**Judson Rd. Water Infrastructure Improvement Project**  
**Solicitation Number: CO-00289-FG**  
**Job No.: 19-7002**

**ADDENDUM #2**  
**October 30, 2020**

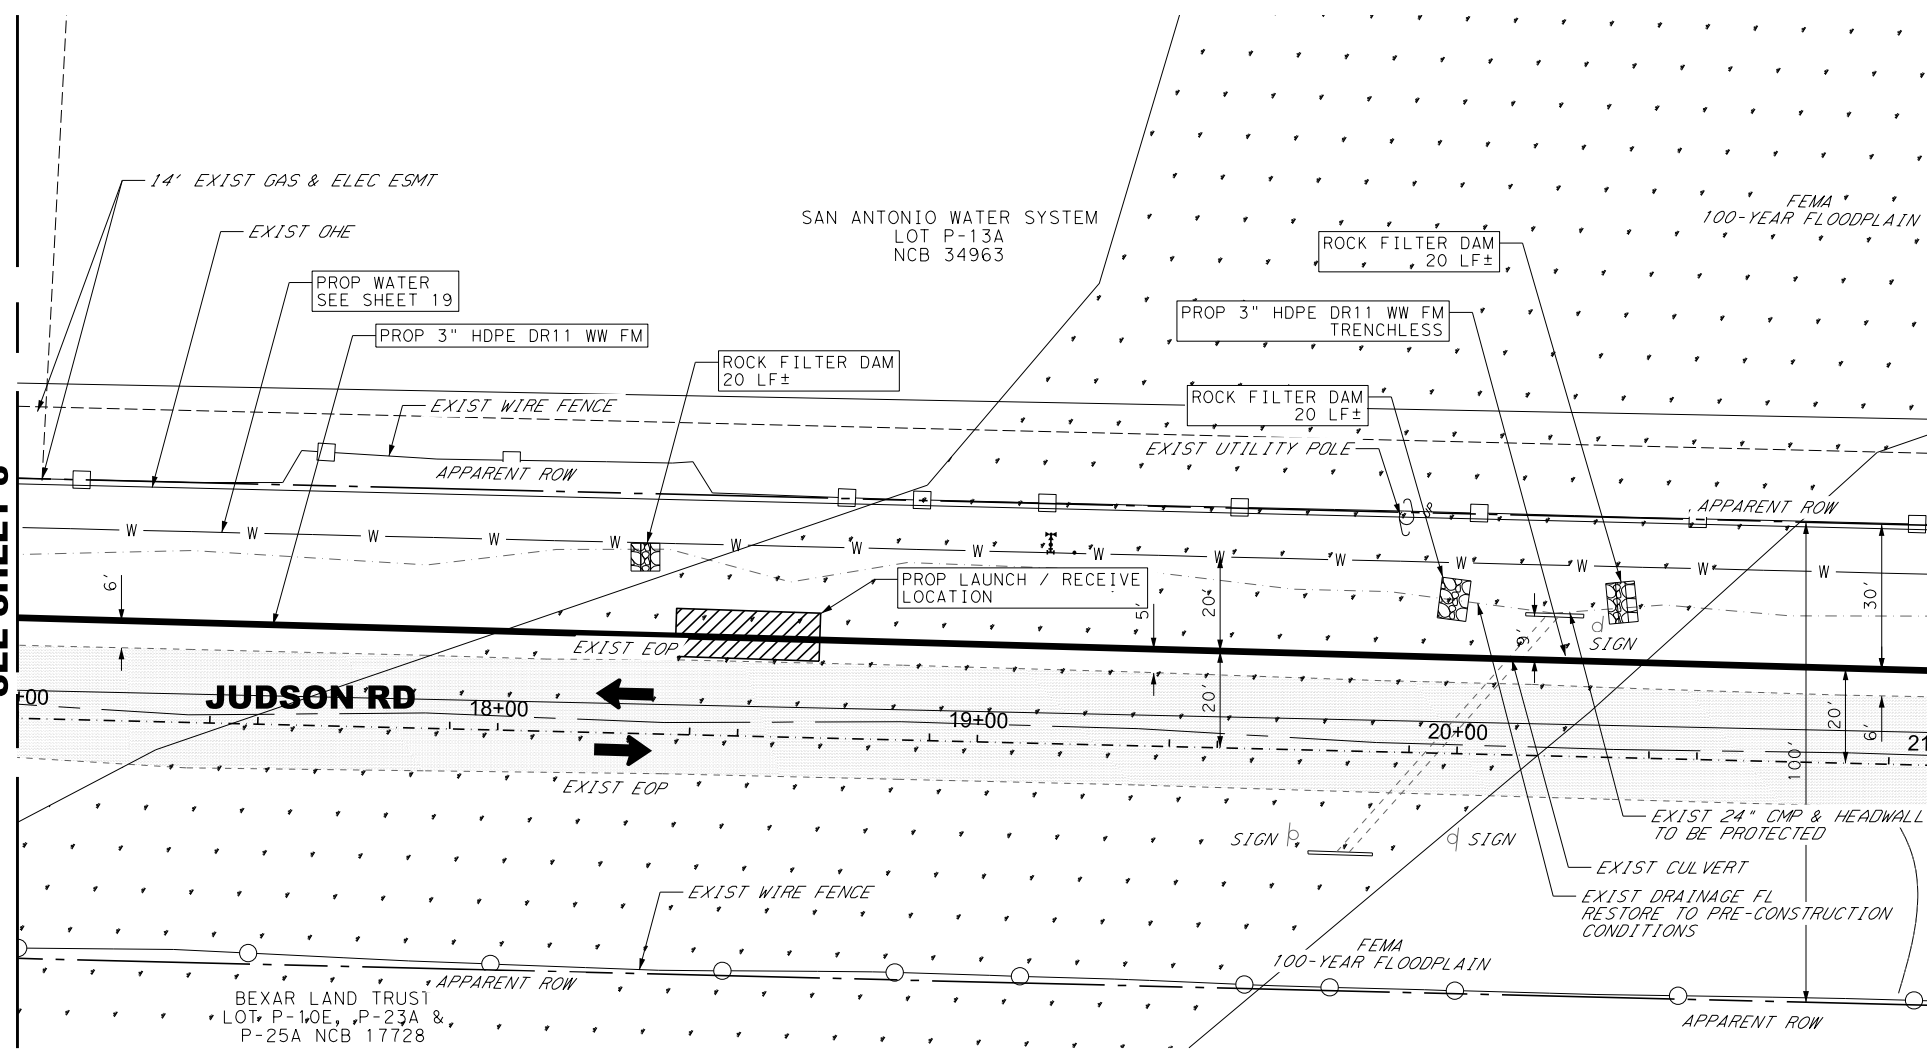
*Removed Item 41 – Two Way Sanitary Sewer Cleanout (3” Pressure).  
Updated Overall Project Quantity Table*

JUDSON RD. WATER INFRASTRUCTURE IMPROVEMENTS  
FORCE MAIN LAYOUT P & P  
STA 17+00 TO STA 21+00  
SHEET 2 OF 11

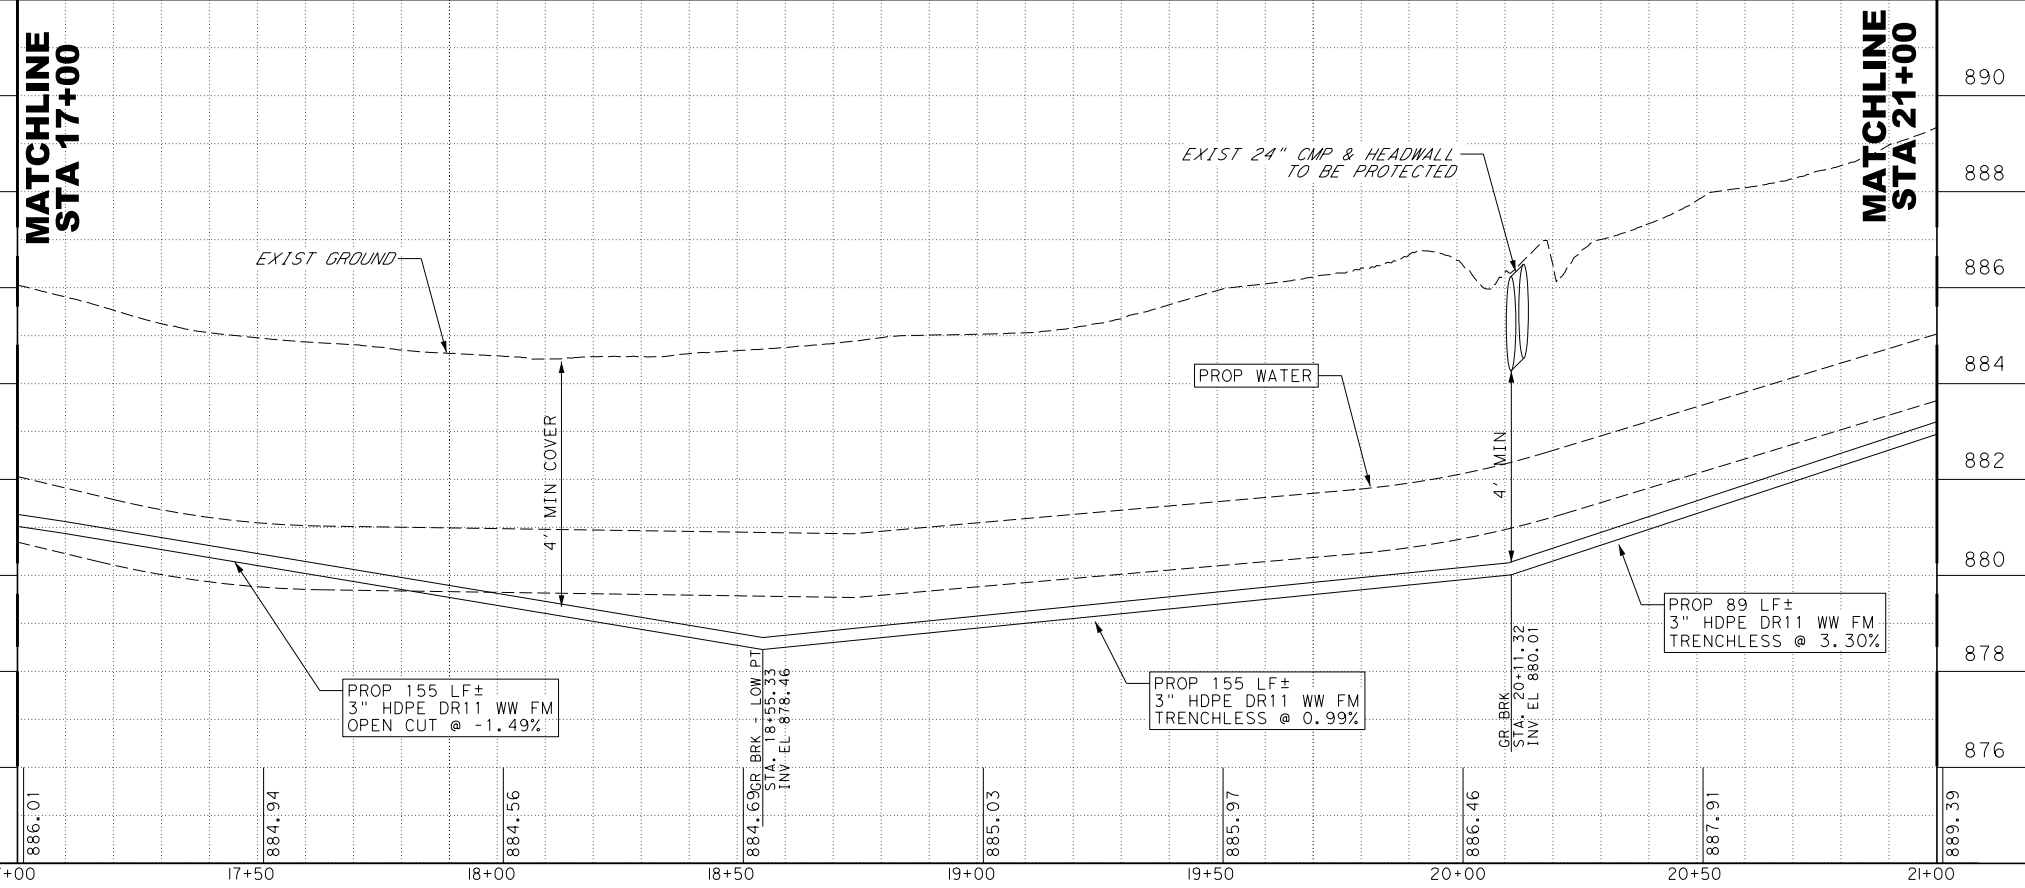
*Removed Two Way Sanitary Sewer Cleanout (3” Pressure) STA 18+50.00.  
Updated Sheet Quantity Table*

JUDSON RD. WATER INFRASTRUCTURE IMPROVEMENTS  
 FORCE MAIN LAYOUT P & P  
 STA 21+00 TO STA 25+00  
 SHEET 3 OF 11

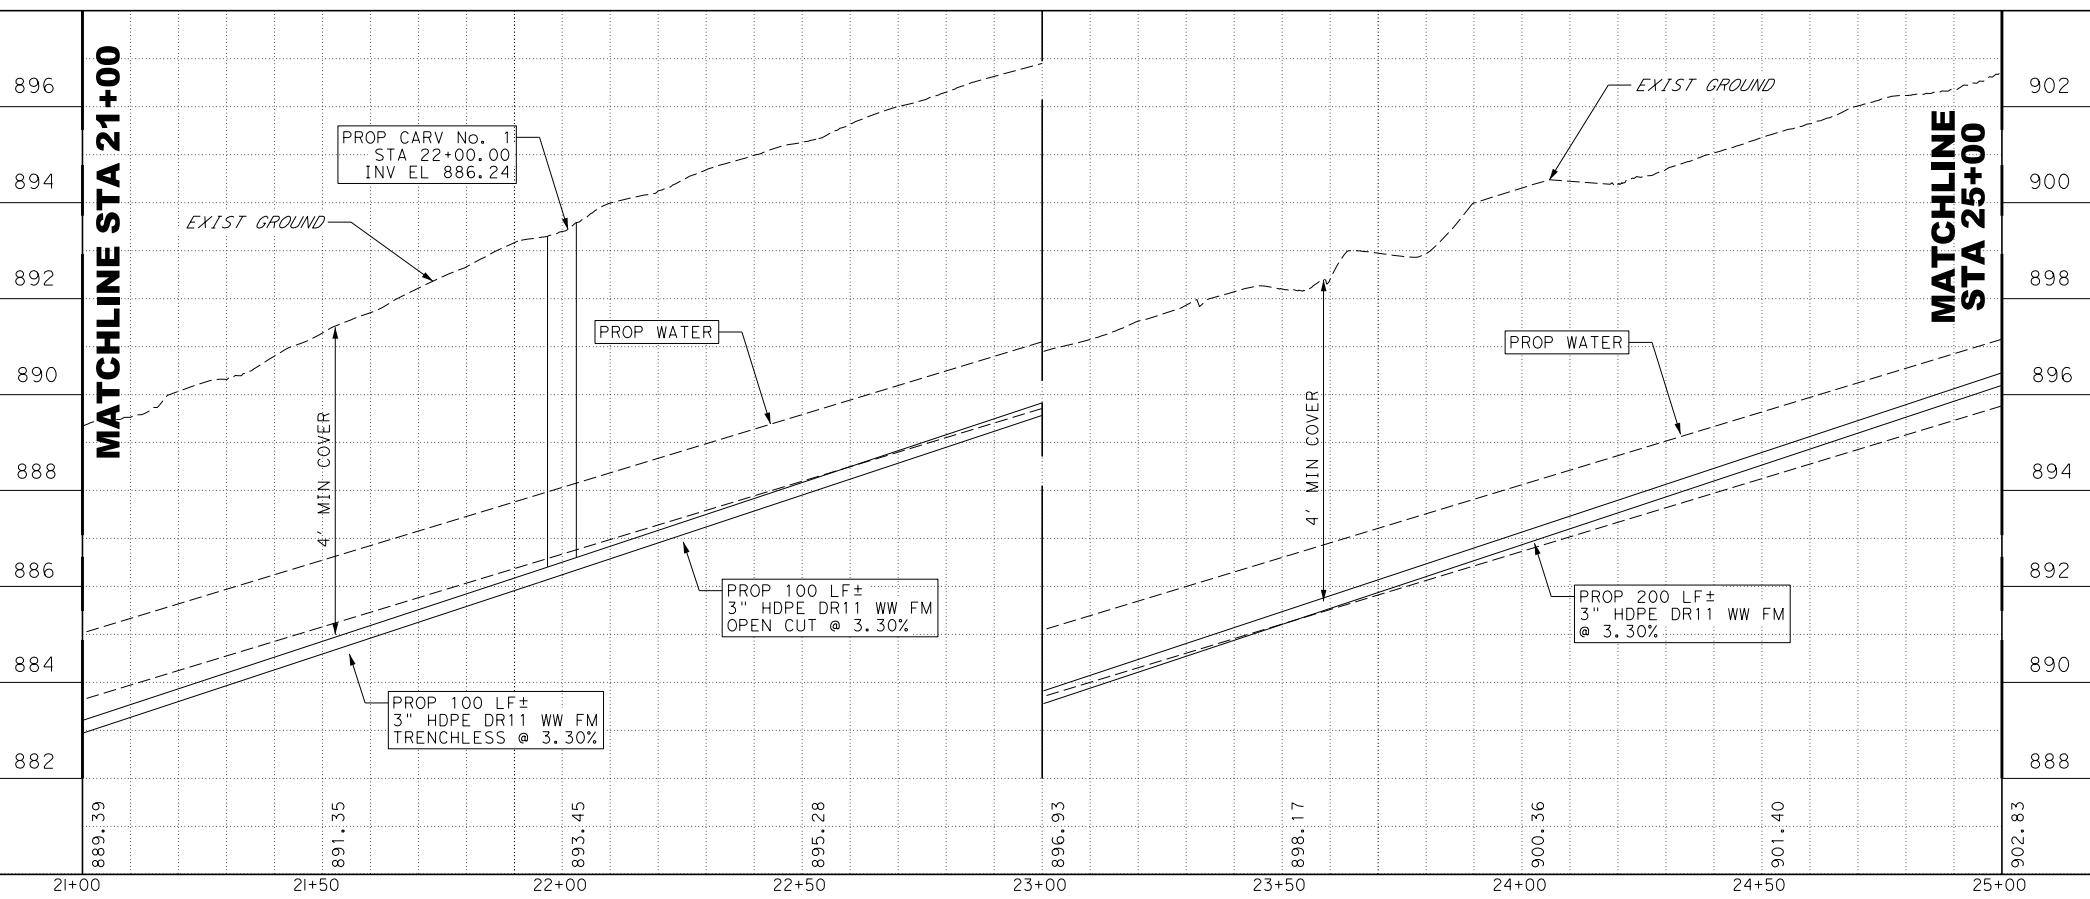
*Removed Two Way Sanitary Sewer Cleanout (3” Pressure) STA 22+50.00.  
Updated Sheet Quantity Table*

JUDSON RD. WATER INFRASTRUCTURE IMPROVEMENTS  
**FORCE MAIN LAYOUT P & P**  
STA 25+00 TO STA 29+00  
SHEET 4 OF 11

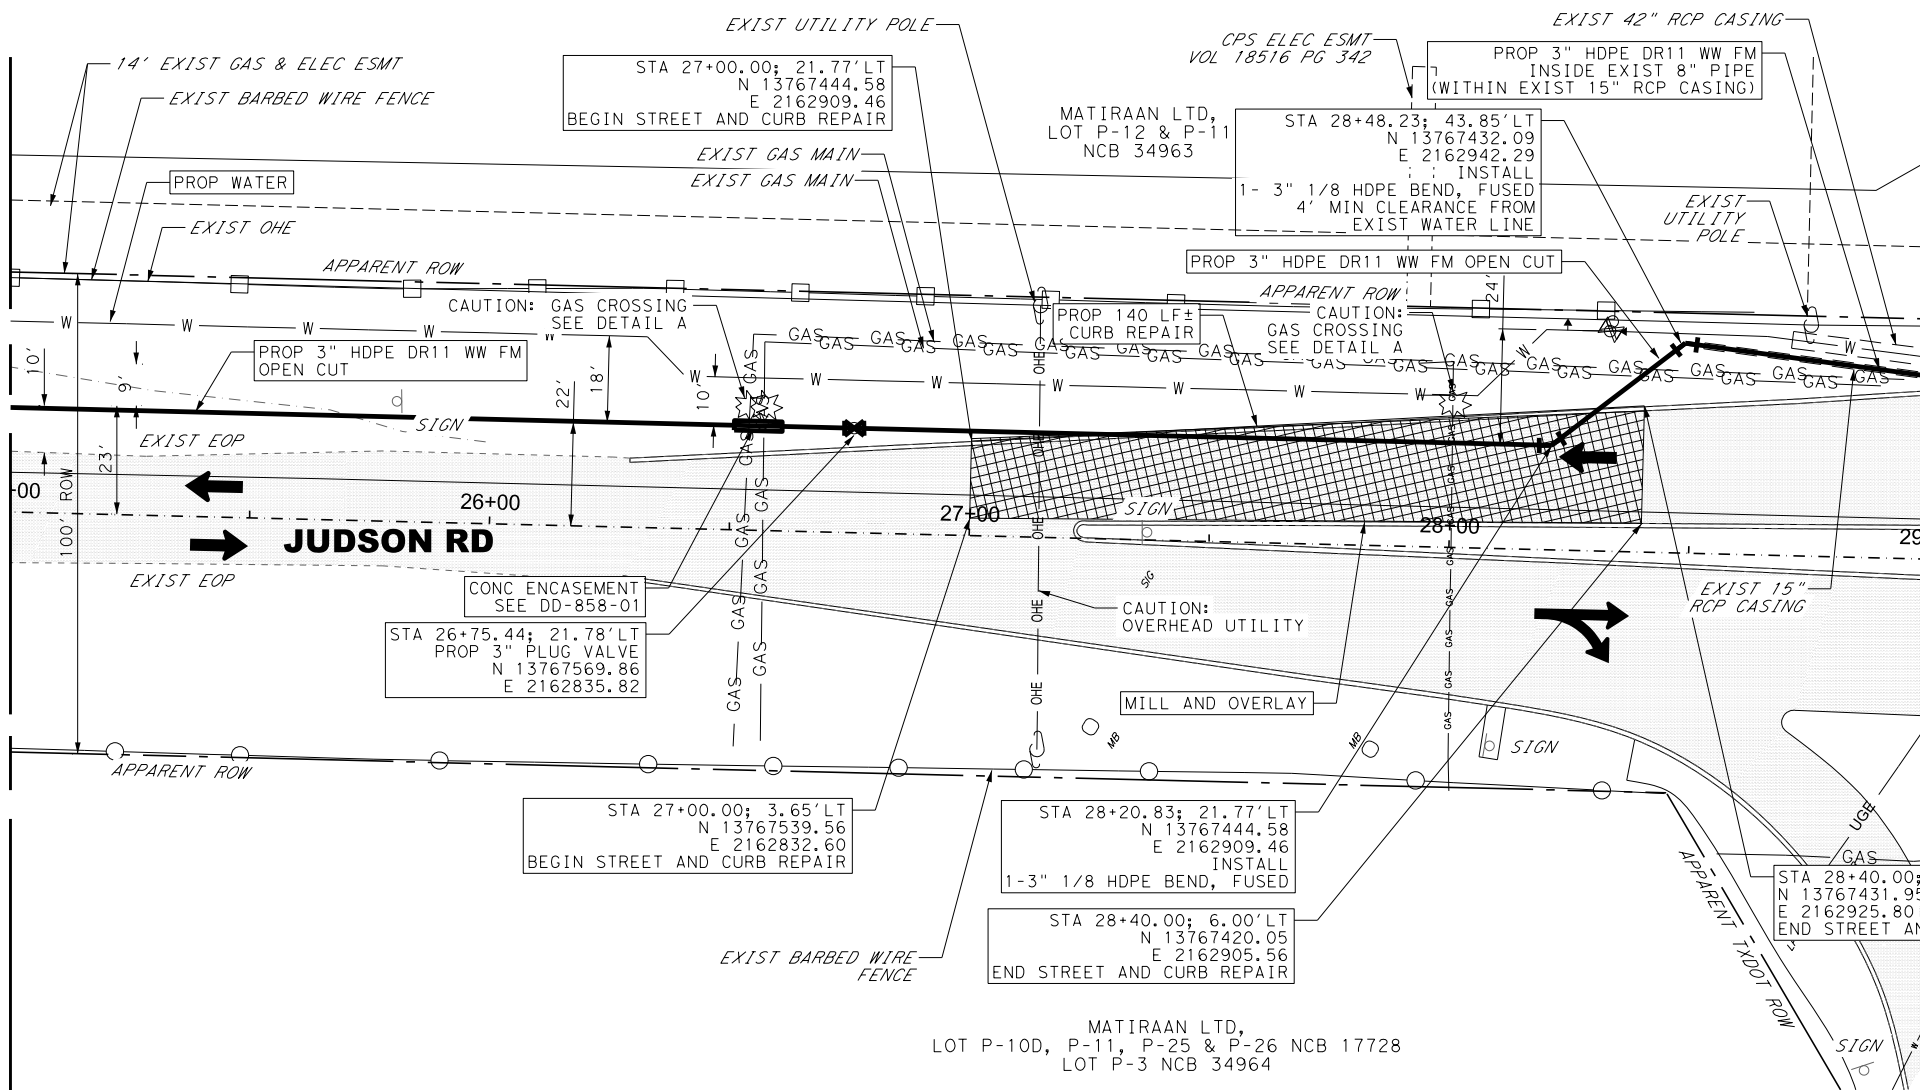
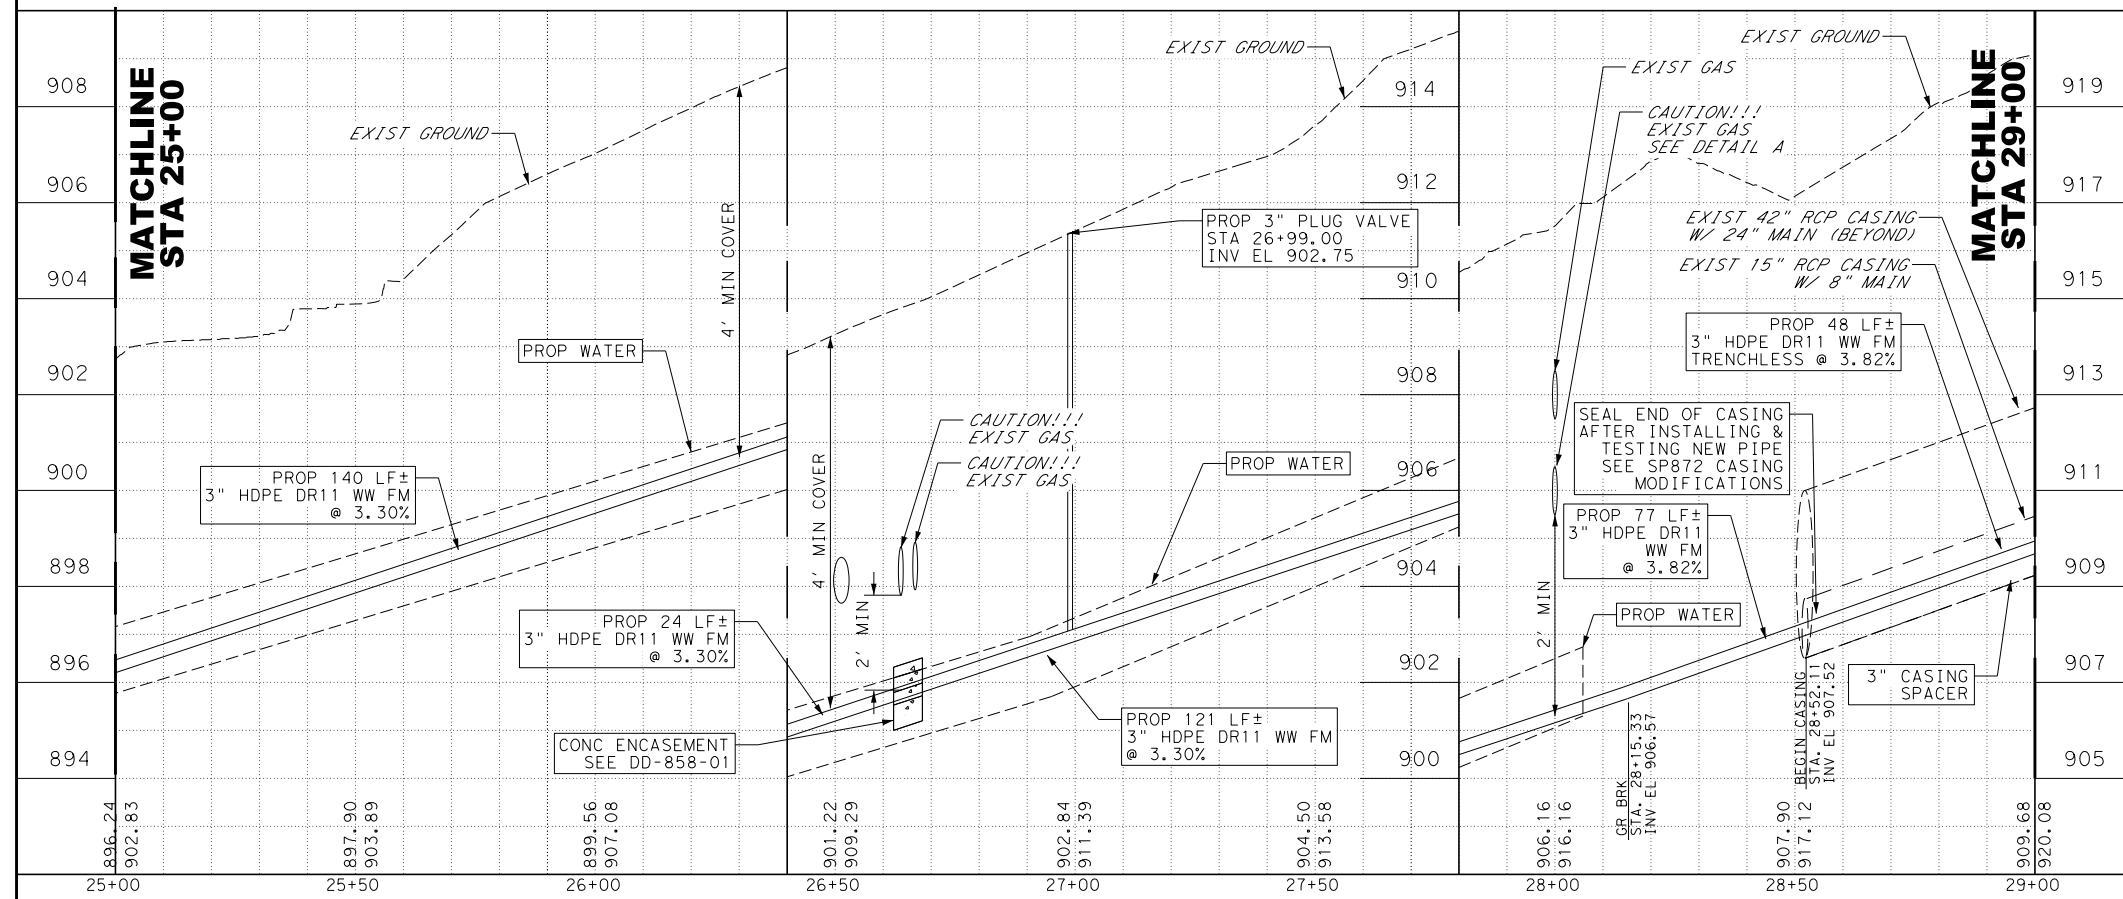
*Removed Two Way Sanitary Sewer Cleanout (3” Pressure) STA 26+69.00.  
Updated Sheet Quantity Table*
